**ADDENDUM NO. 2**  
**PHILLIP C. SHOWELL ELEMENTARY SCHOOL**  
**CLASSROOM ADDITION**  
Selbyville, Delaware 19975

May 4, 2015

The documents for the above referenced project, Project Manual, dated March 2, 2015 and Drawings, dated March 25, 2015, as well as subsequently issued addenda, are amended as follows:

1 FINISH PATTERN PLAN

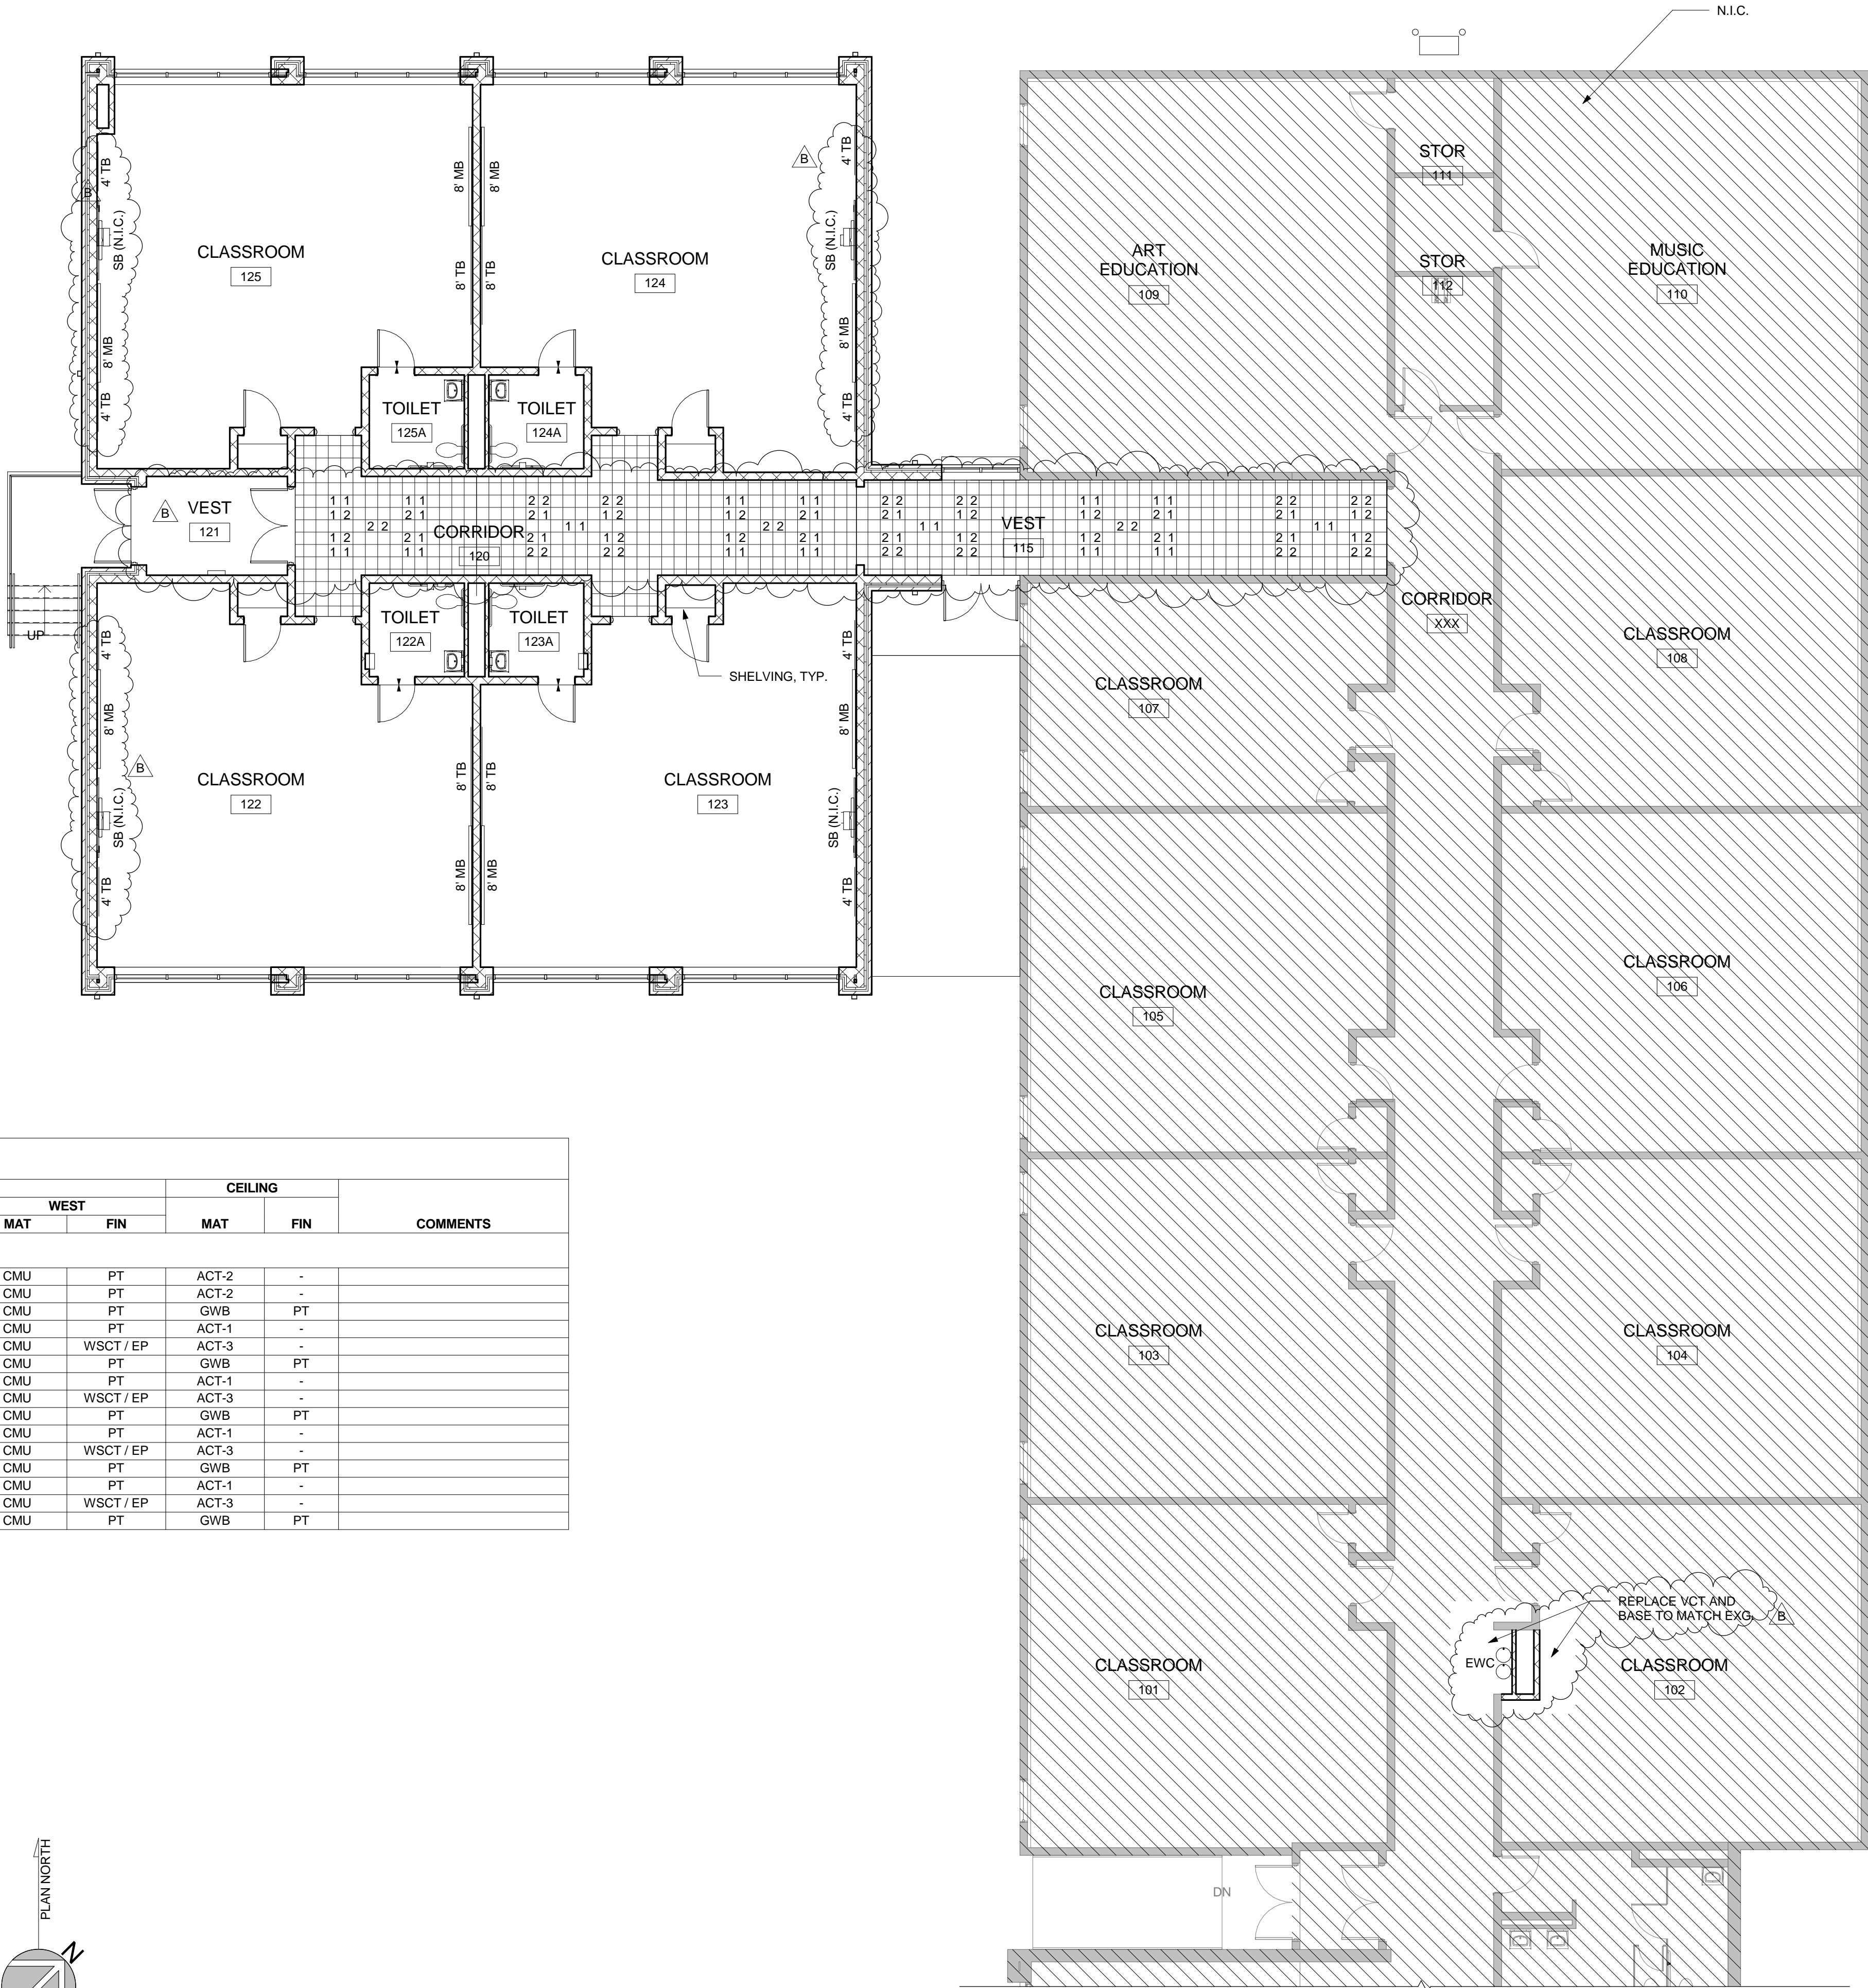
- a. Detail 1:
    - i. REVISE teaching surfaces at Classrooms 122, 124, and 125.
    - ii. REMOVE VCT pattern at Vestibule 121 (floor finish is carpet, as scheduled).

- iii. REVISE VCT floor pattern at Vestibule 115 and Corridor 120.
    - iv. ADD note at new EWC and chase near Classroom 102 as follows:  
 "REPLACE VCT AND BASE TO MATCH EXG."

2 CERAMIC TILE WAINSCOT DETAIL

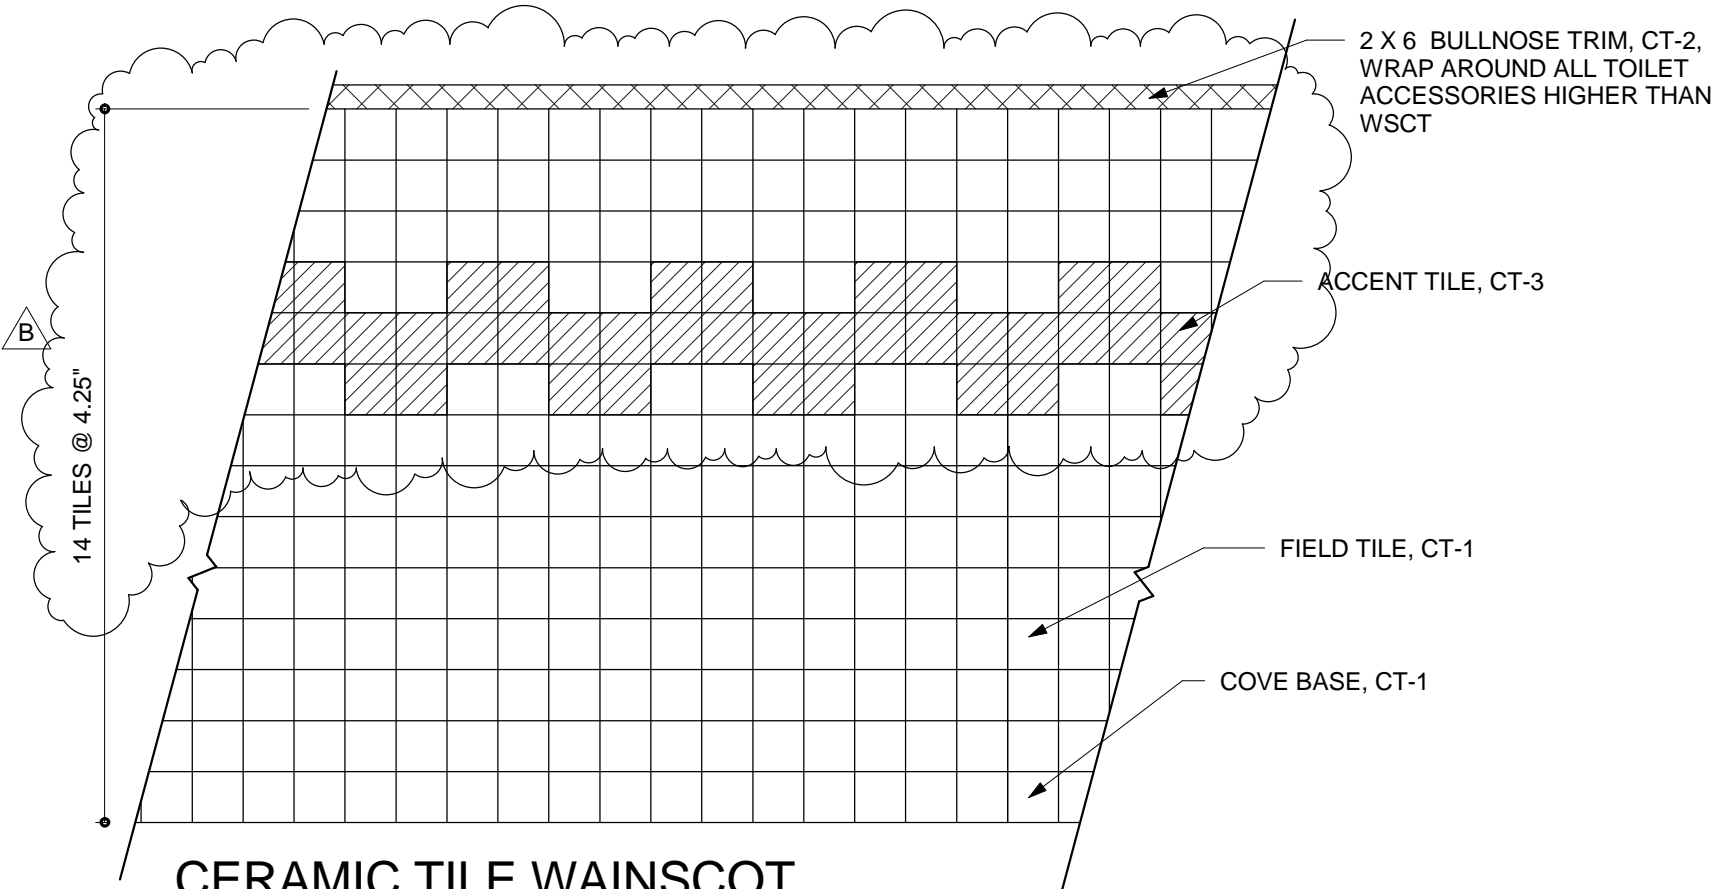
- b. Detail 2: REVISE from eleven (11) tiles to fourteen (14) tiles high, and raise accent band by one (1) tile.
  - c. Finish Schedule Legend
    - i. REPLACE CPT-1 and CPT-2 with "CPT, TILE WALK OFF MAT, 096816".

4 WALL SECTION AT SF-2

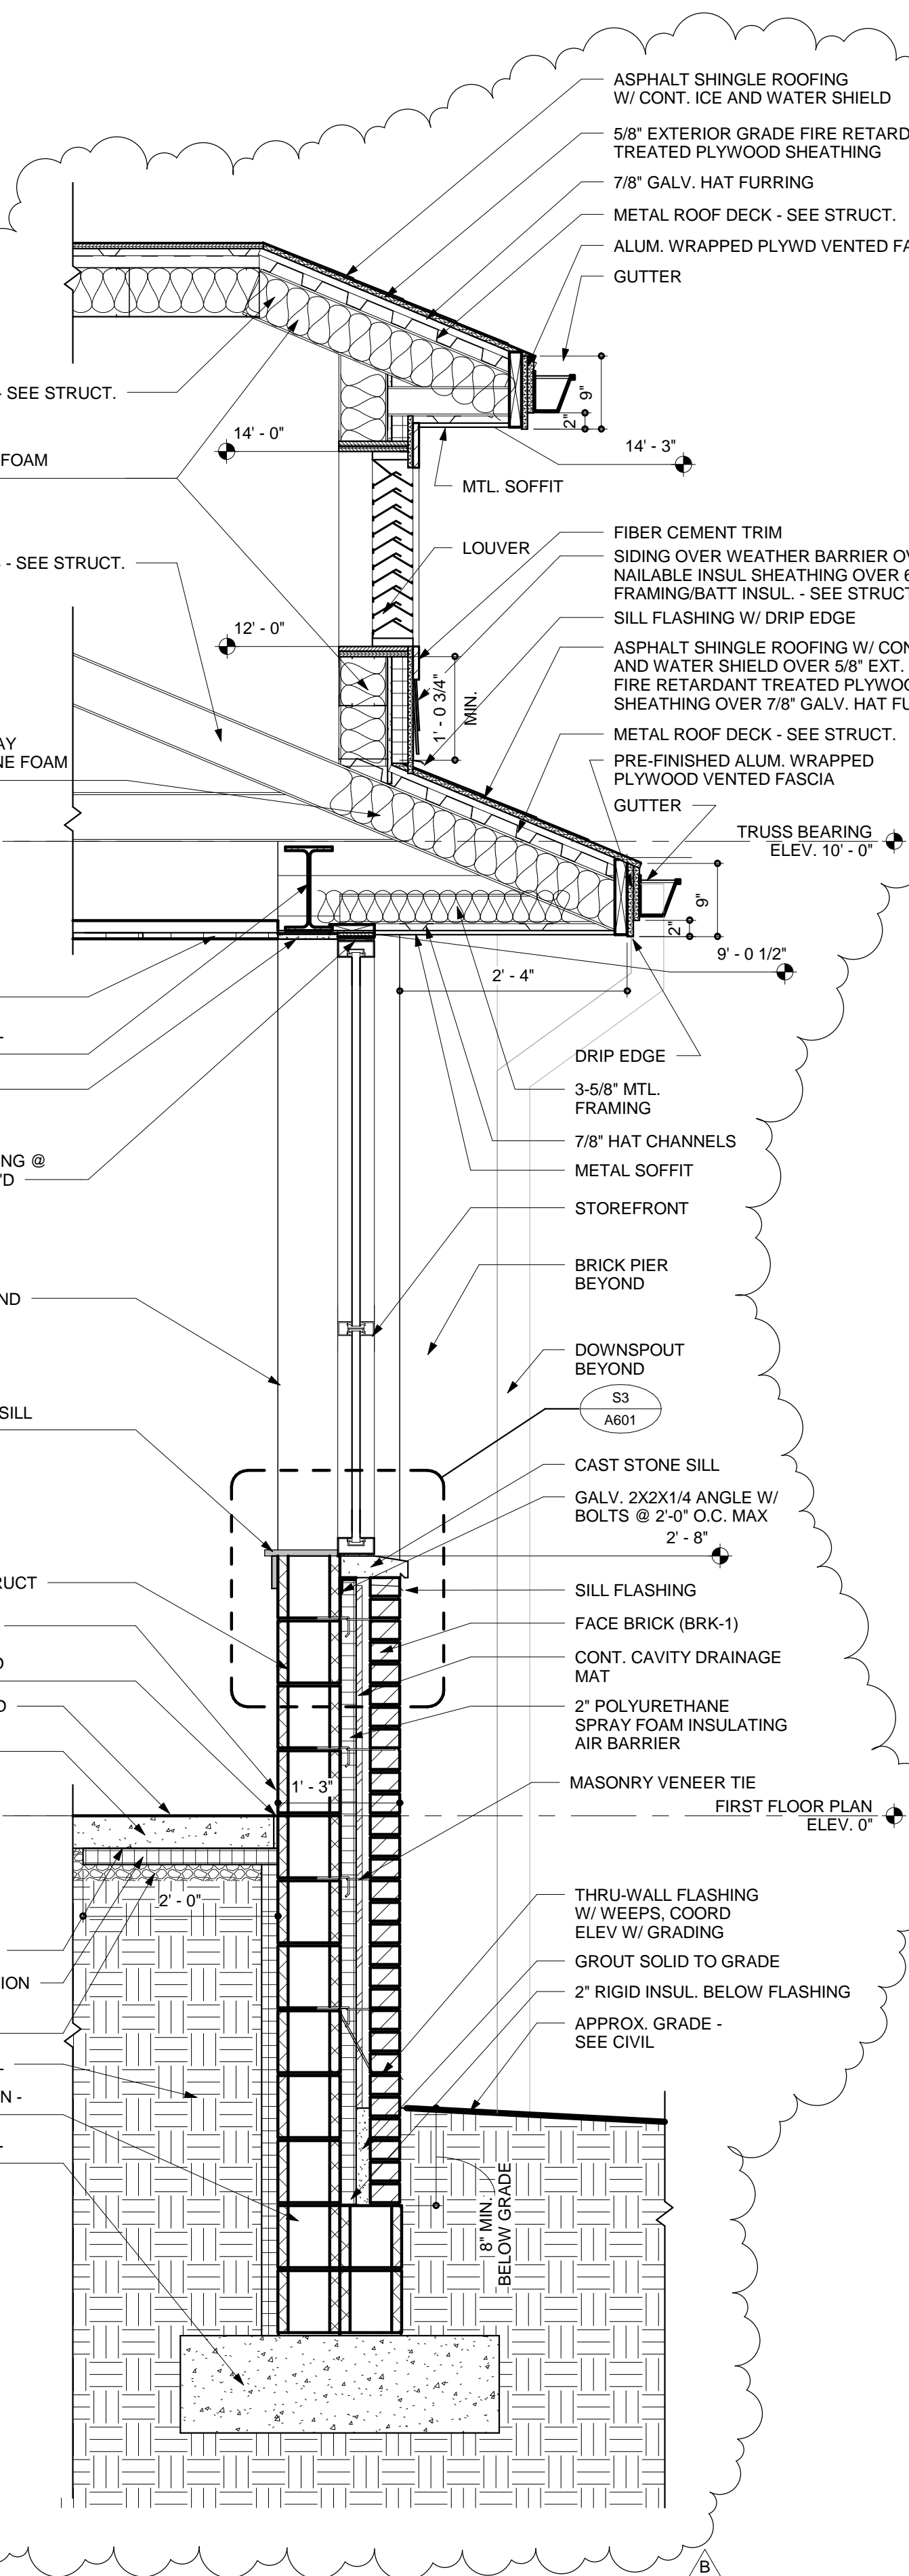
12. A301 Building and Wall Sections
- a. ADD detail 4, per attached drawing.
  - b. REPLACE detail 5, per attached drawing.
13. A501 Wall Types and Miscellaneous Details
